Central Sewershed Package 7-Brackenridge High School
Solicitation Number: CO-00423
Job No.: 18-4543

ADDENDUM 02

May 28, 2021

POLYMER CONCRETE MANHOLE DETAIL

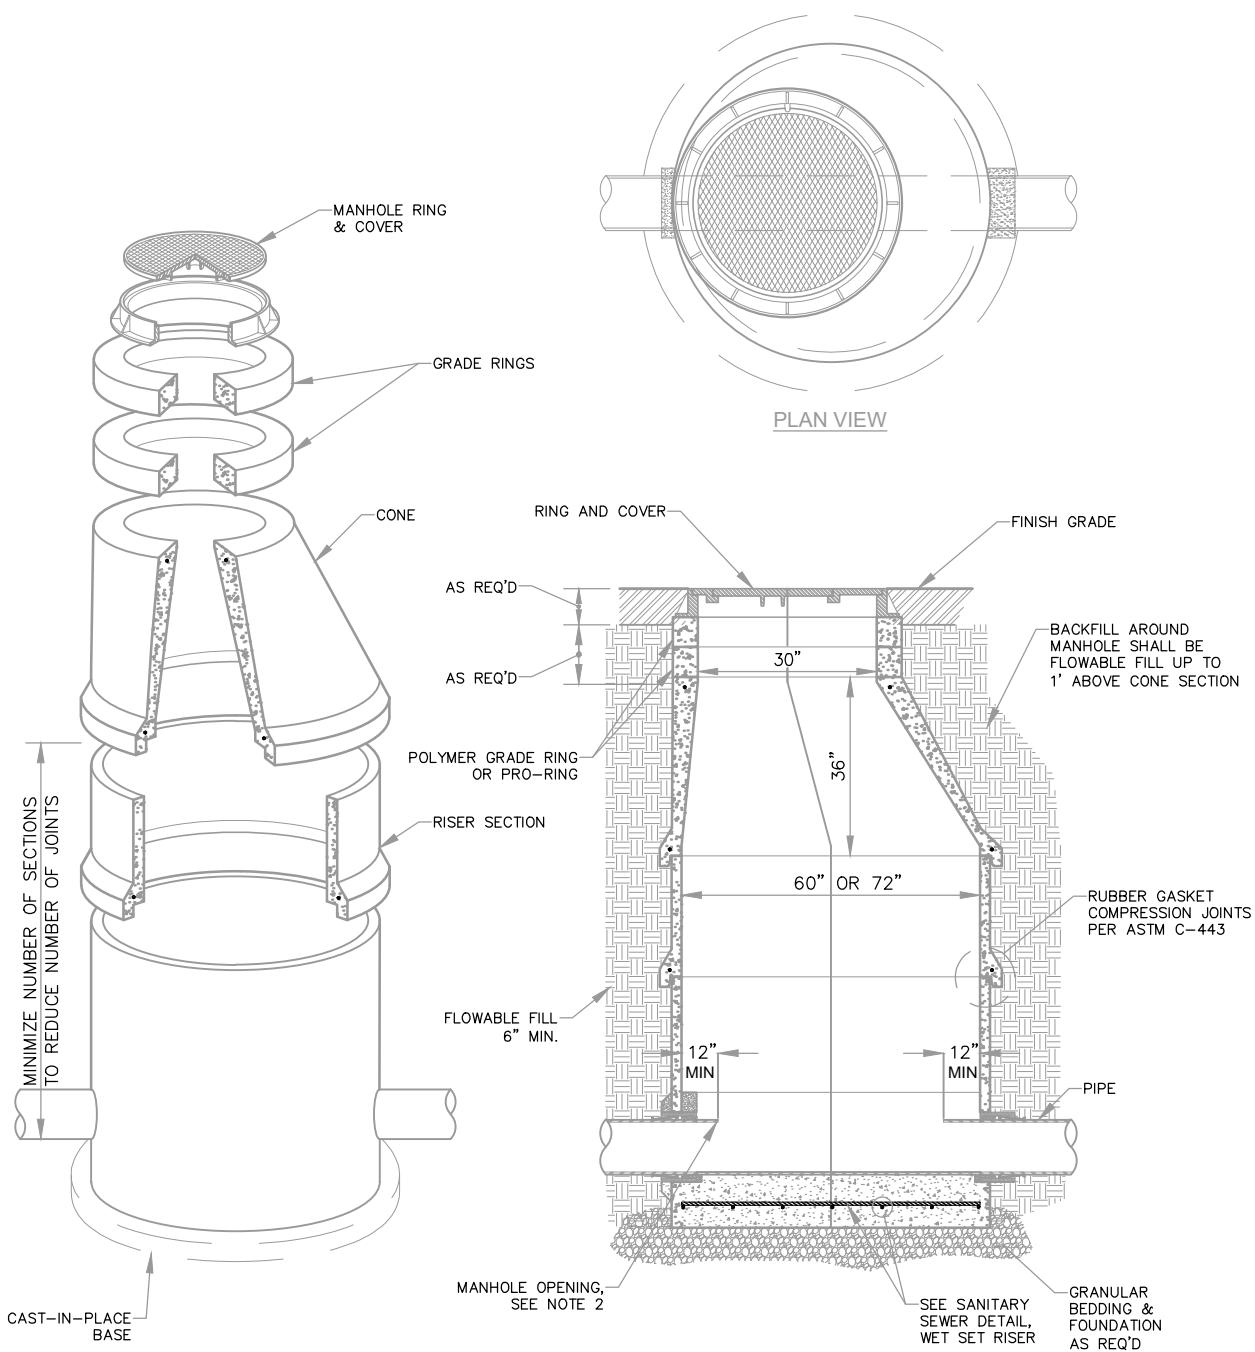
1. Can you clarify the type of Backfill for Polymer Manholes and can you provide a detail? Also, can Fiberglass manholes be considered in lieu of Polymer?

16. Is there a detail for Polymer Manholes backfill requirements?

17. Will Tee-Base Fiberglass Manholes be allowed as an alternate to bid line item No. 11 “60” Polymer Concrete Manholes”? The Tee-Base Fiberglass Manholes are used in conjunction with FRP pipe. Tee-Base Fiberglass Manholes are approved and specified by SAWS Item No. 852. Recently bid projects have specified Tee-Base Manholes.

Answer: Flowable fill will be used as backfill for polymer concrete manholes included in this project. Flowable fill as backfill shall be considered incidental to the manhole bid item and will not be paid separately. A detail is attached to this Addendum showing the use of flowable fill as backfill. Fiberglass manholes will not be considered as an alternative.

Answer: Please refer to manhole detail included in this Addendum, see Attachment 3.

Answer: Tee bases will be allowed; however, Fiberglass manholes risers will not be bid as an alternative. Please refer to Attachment 3, polymer concrete manhole detail included in this Addendum for more information.

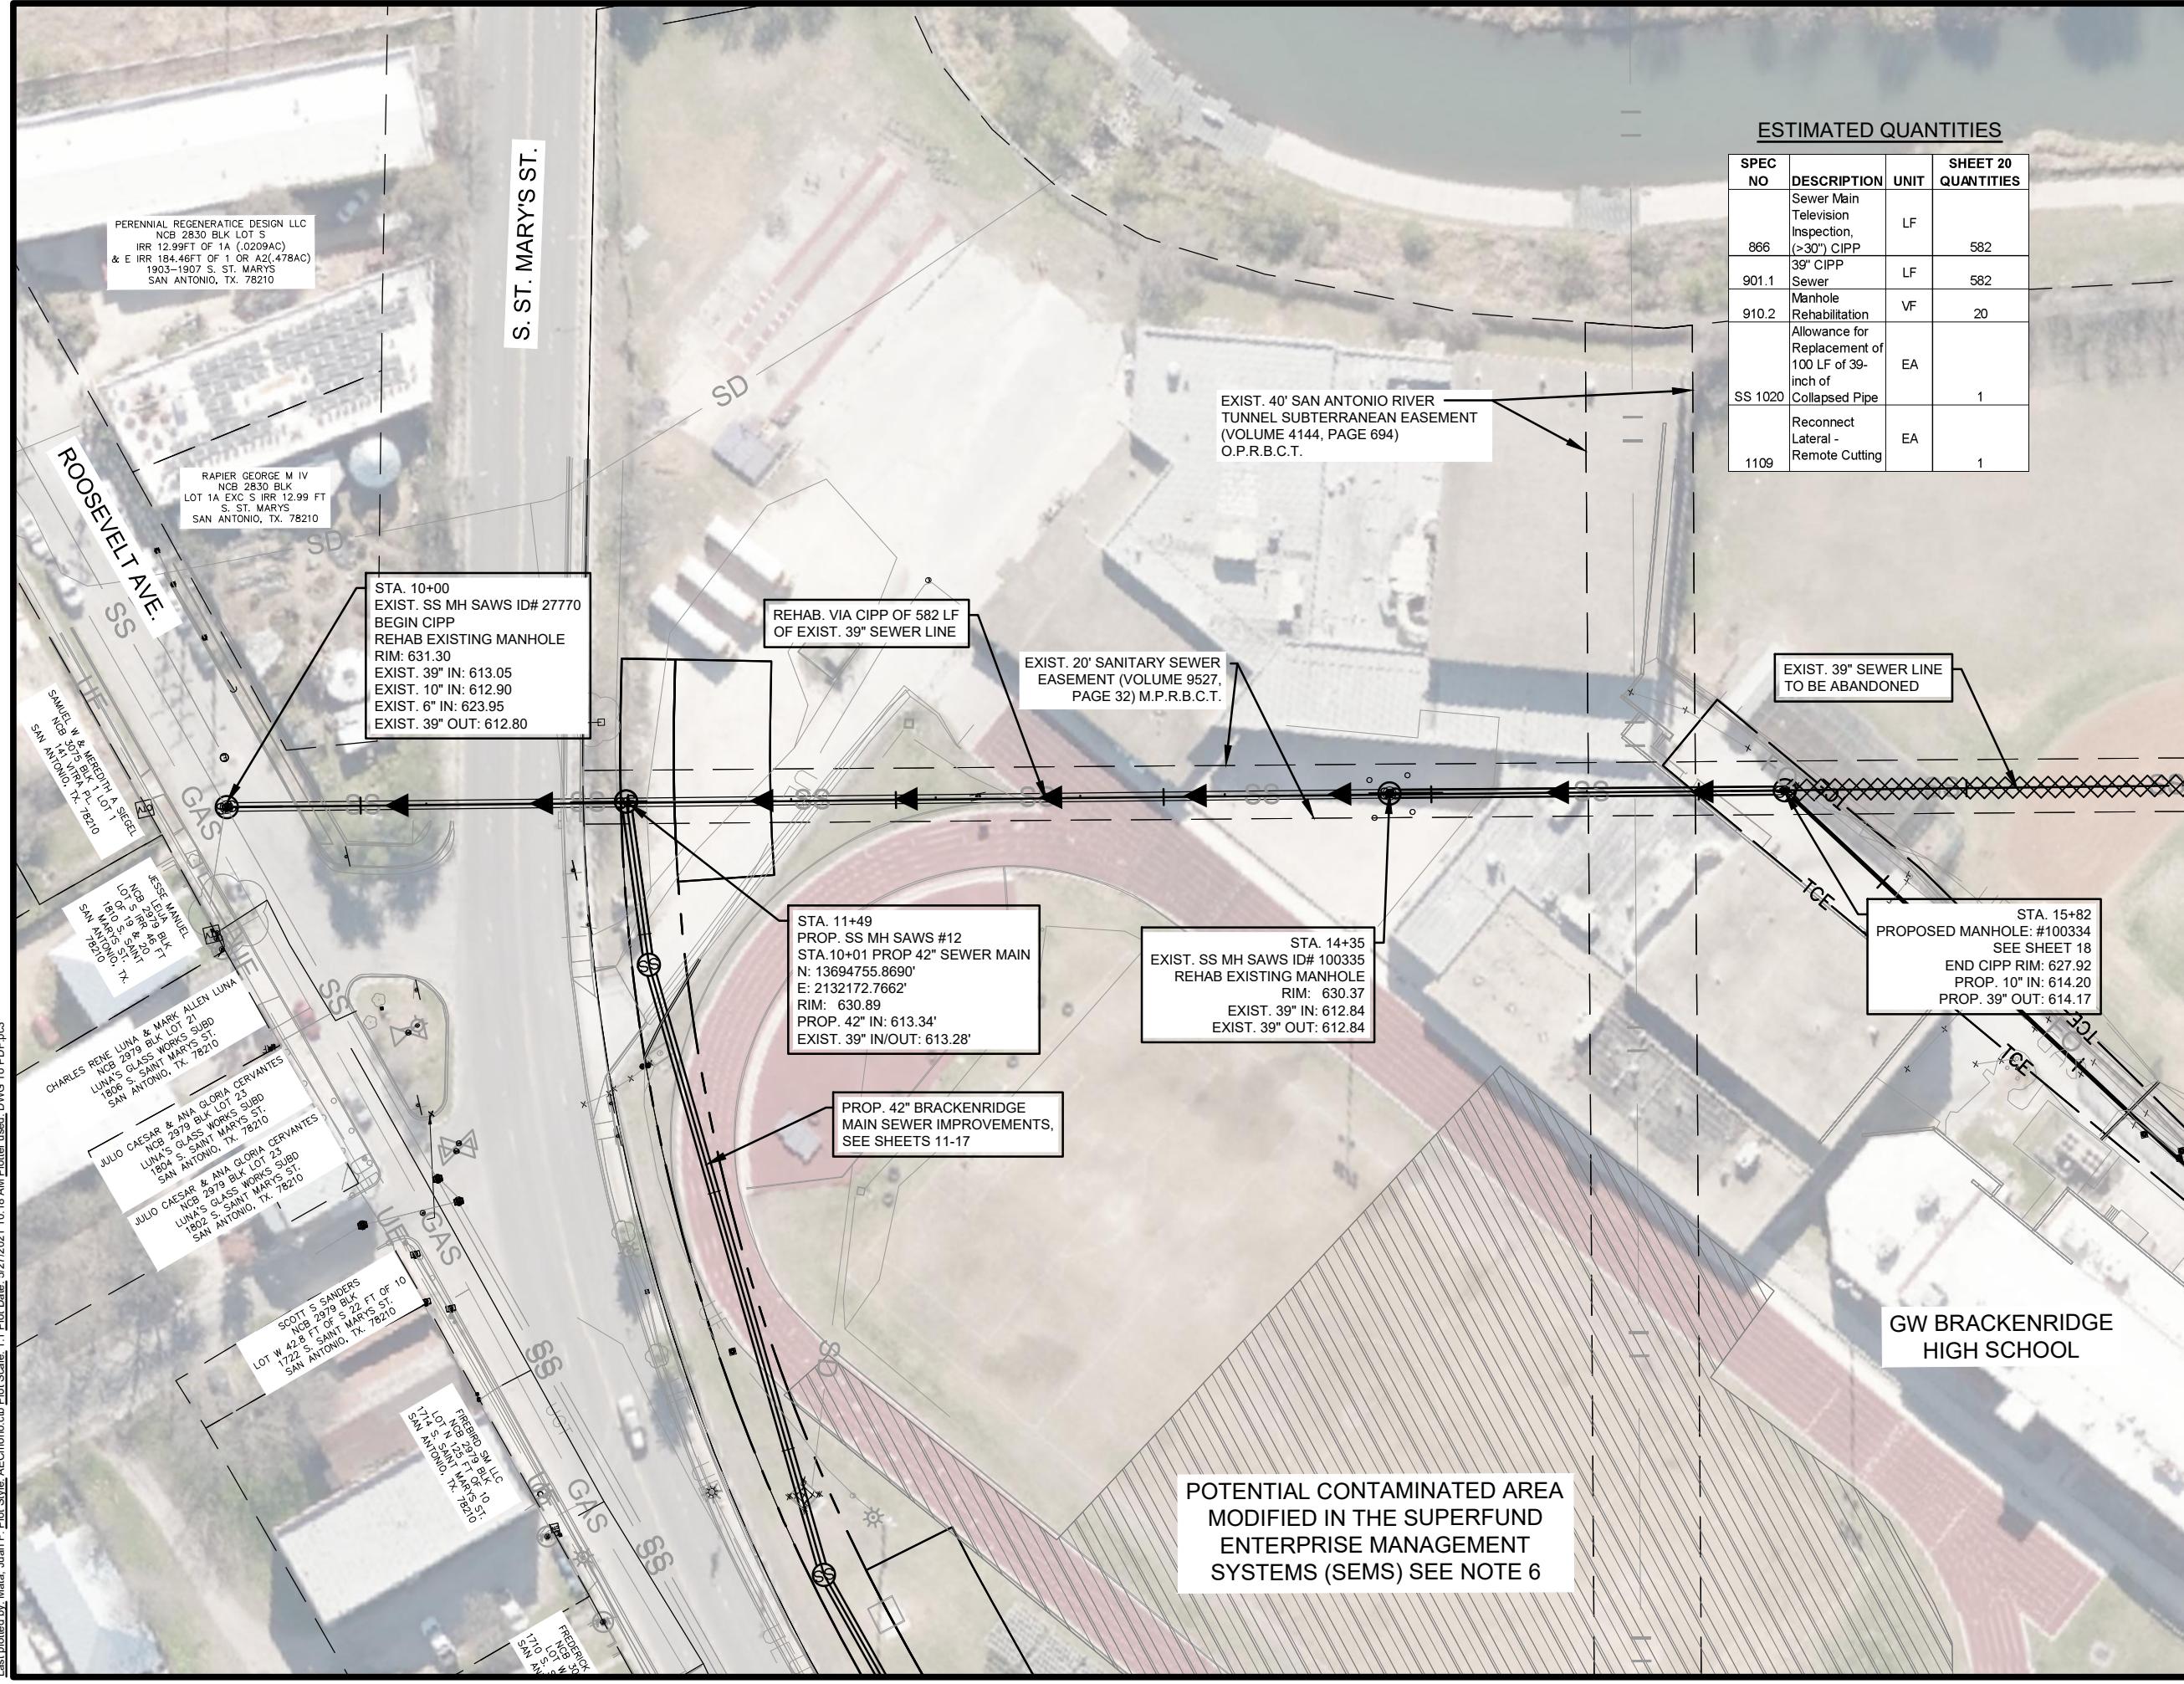
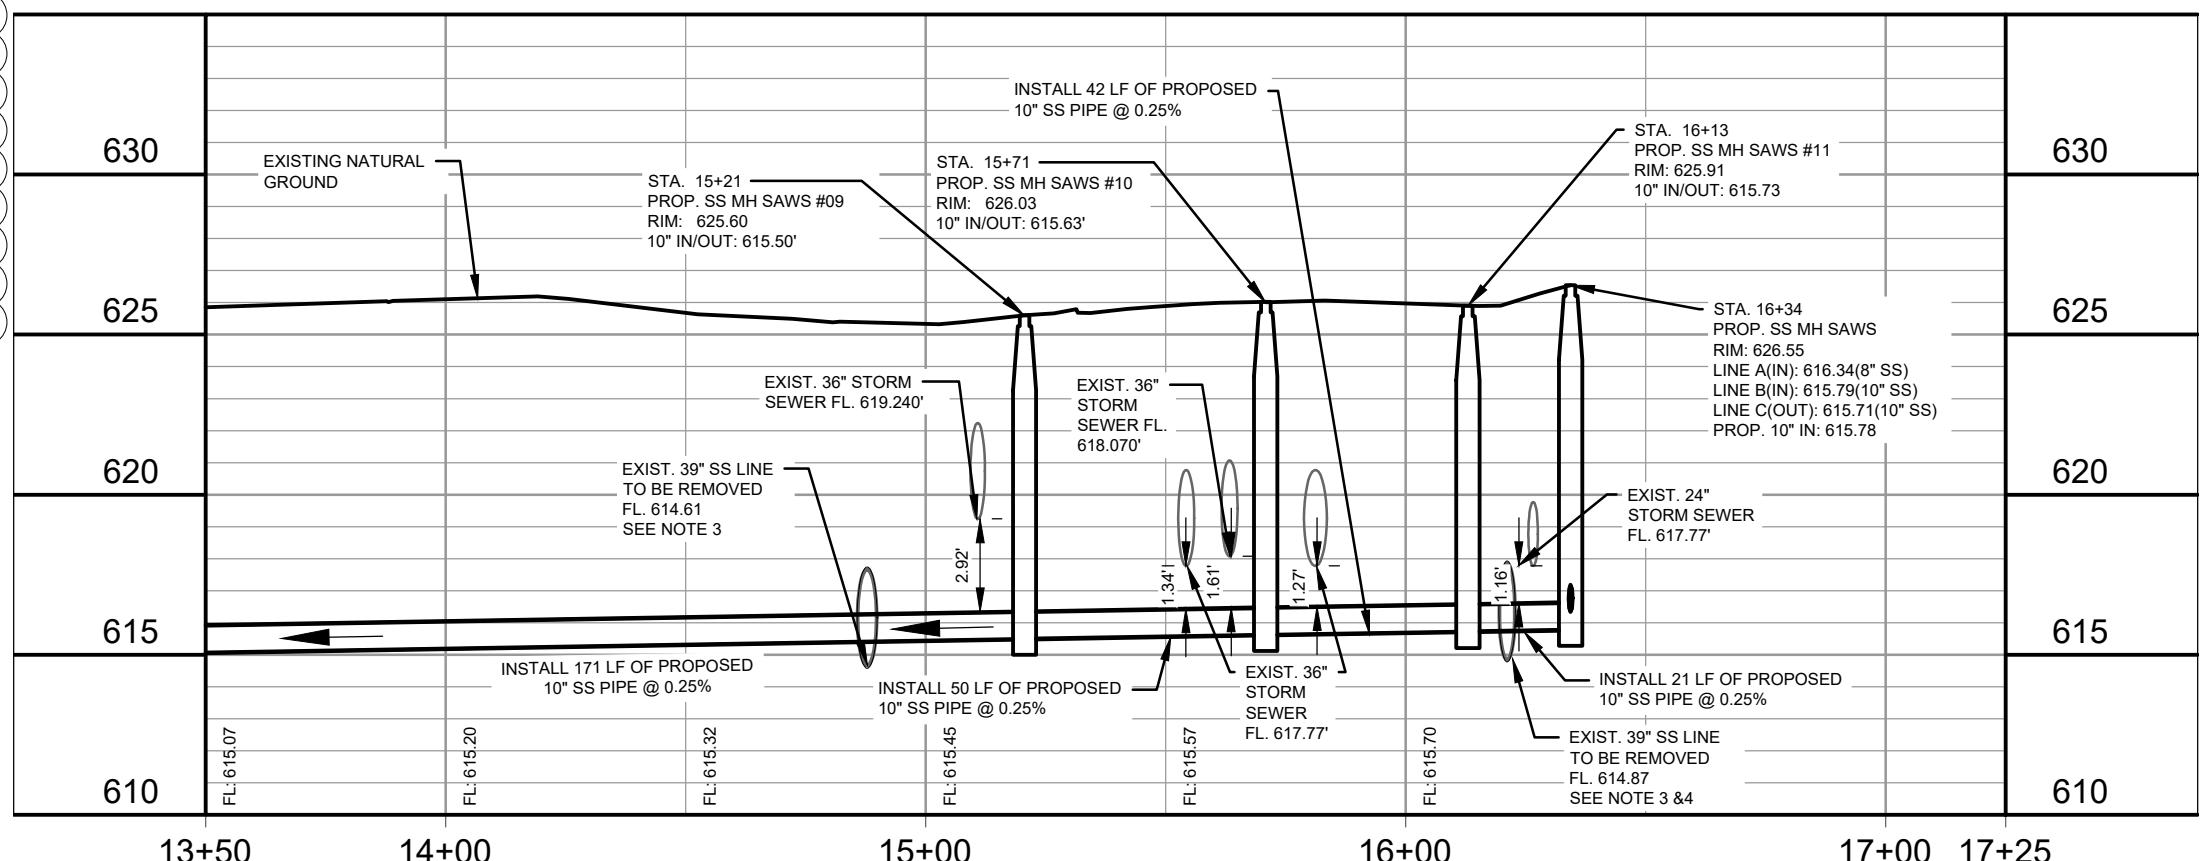
23. The estimated quantities on drawing sheet 19 shows that there is 1 EA lateral to be reconnected by remote cutting, but there is no CIPP lining work on this sheet or other work that would normally require a lateral to be remotely reinstated. Please clarify.

4. Remove Sheet 19, Brackenridge Lateral 1 Plan and Profile Sta. 13+50 – 16+34, and replace with revised Sheet 19 attached to this Addendum.
- a. Remove bid item 1109, Reconnect Lateral – Remote Cutting, and update call note at Sta. 16+34 to include the following:

Answer: There is no remote cutting bid item on Sheet 19. Contractor shall reconnect existing lateral to new manhole at Sta. 16+34, at no additional cost to the owner.

- i. "RECONNECT EXISTING LATERAL, AT NO ADDITIONAL COST TO THE OWNER."
5. Remove Sheet 20, Brackenridge CIPP Improvements, and replace with revised Sheet 20 attached to this Addendum.

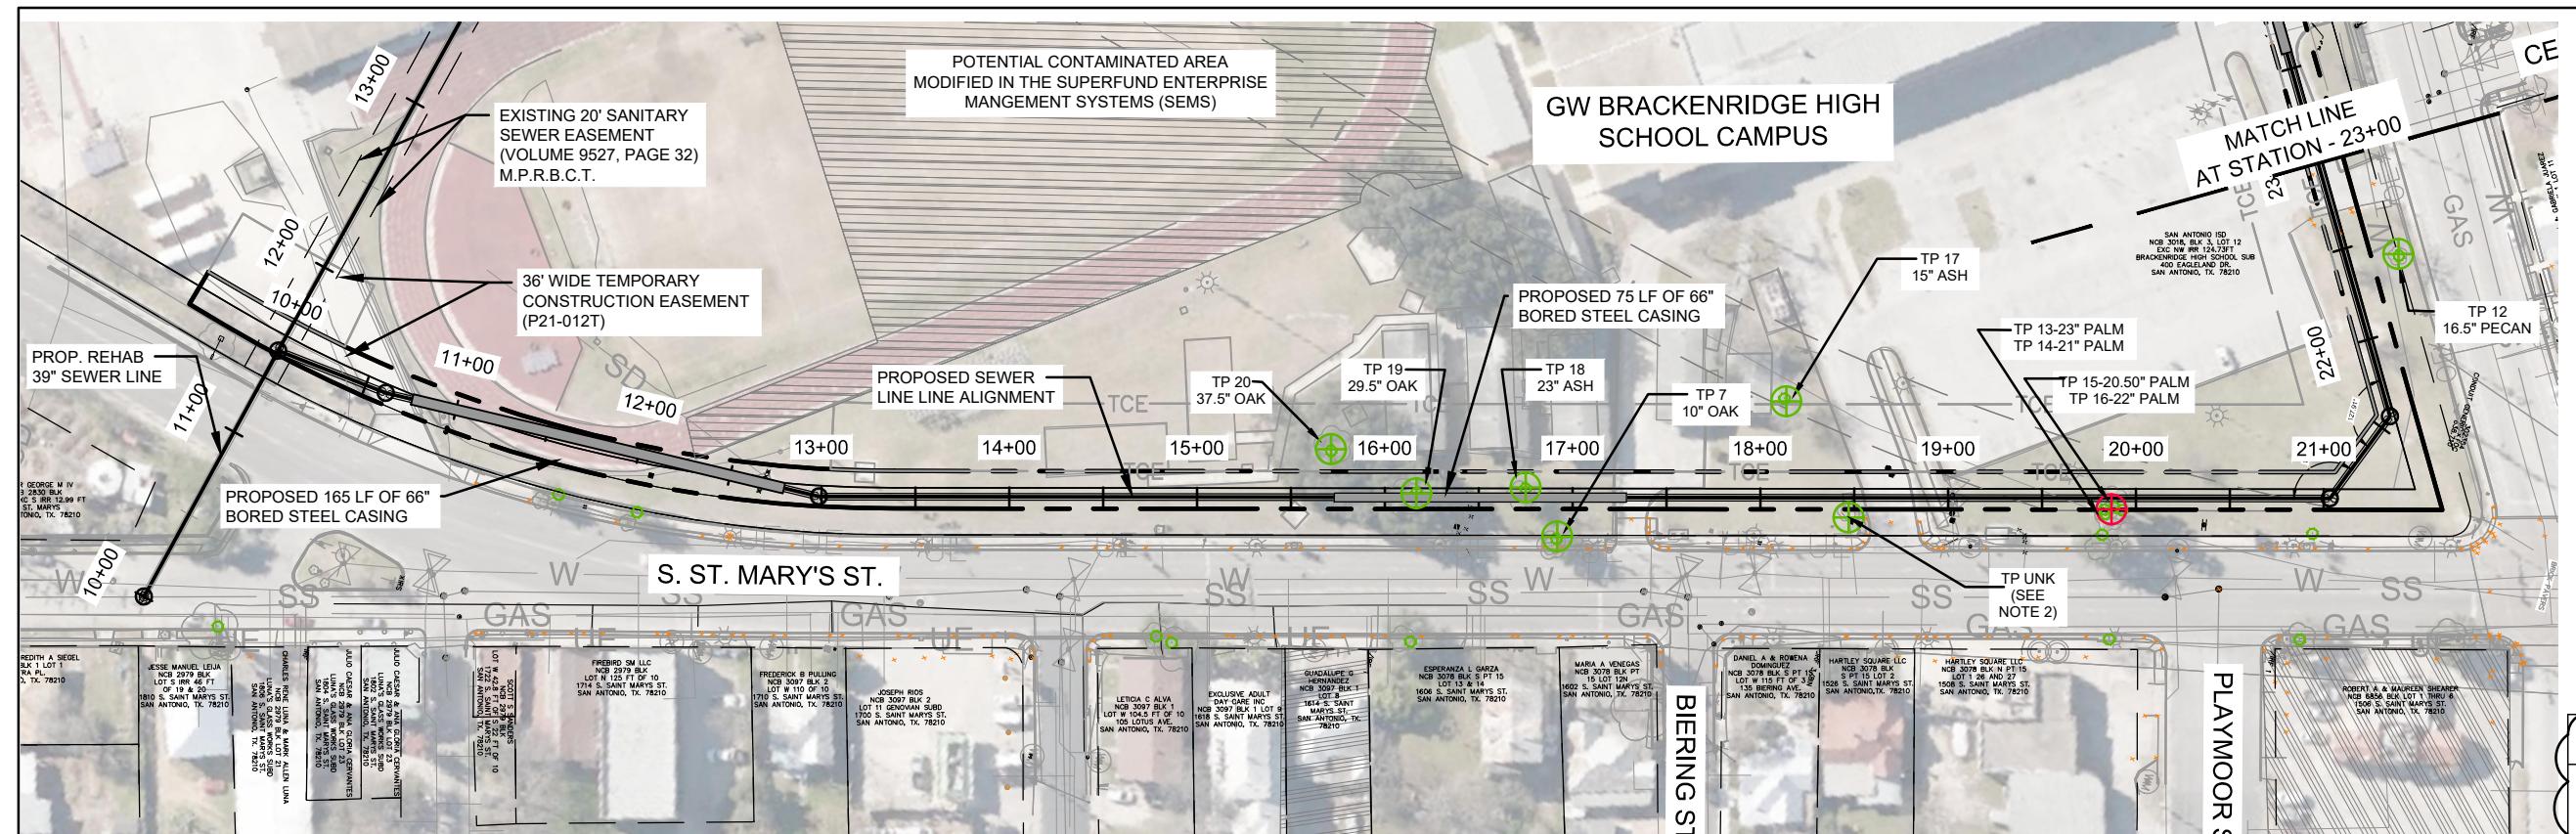
24. Note 3 on drawing sheet 20 indicates that the temporary manhole would be incidental work to the CIPP bid item, but since it appears this manhole is needed for bypass, shouldn't it be incidental to the bypass bid item instead?

Answer: Note 3 under the sheet titled Brackenridge CIPP Improvements, sheet 20 of 32, will be corrected to state that the temporary manhole will be incidental work to the Bypass Bid Item No. 48, Large Diameter Bypass Pumping for Sanitary Sewers (S. St. Mary's St.) – Bypass Pumping No. 2 & 3.

- a. Replace Note 3 with the following:
- i. "INSTALLATION AND ABANDONMENT OF TEMPORARY MANHOLE, WITH ITS RESPECTIVE REPAIR AND RESTORATION WORK OF THE AREA, SHALL BE COORDINATED WITH SAISD AND SAWS AND SHALL BE CONSIDERED SUBSIDIARY TO BID ITEM 864-S2, LARGE DIAMETER BYPASS PUMPING FOR SANITARY SEWERS (S. ST. MARY'S ST.) – BYPASS PUMPING NO. 2 & 3."
